MILITARY SPECIFICATION

Circuit Card Assembly: 10548119
(DECODER, RCFD)

This Amendment forms a part of Military Specification MIL-C-50652/3(MU) dated 15 April 1971.

Figure 2. Test Fixture Setup, Change: From: "Z1 Output J" To: "Z1 Output K"

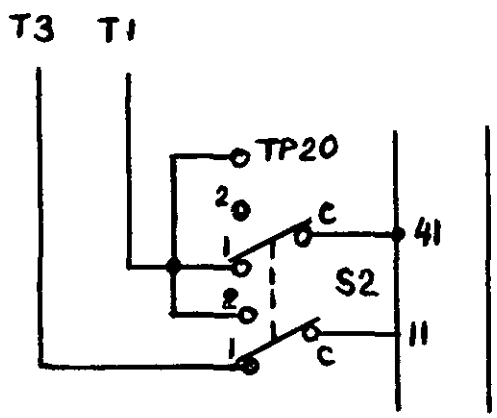
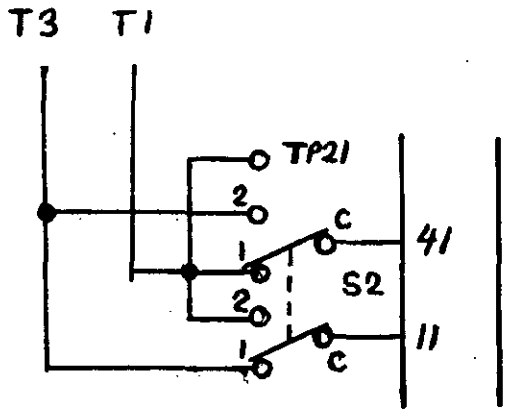
S2 Wiring, add wire between T3 and S2-2, Change TP callout at S2, See Below:

From: To:
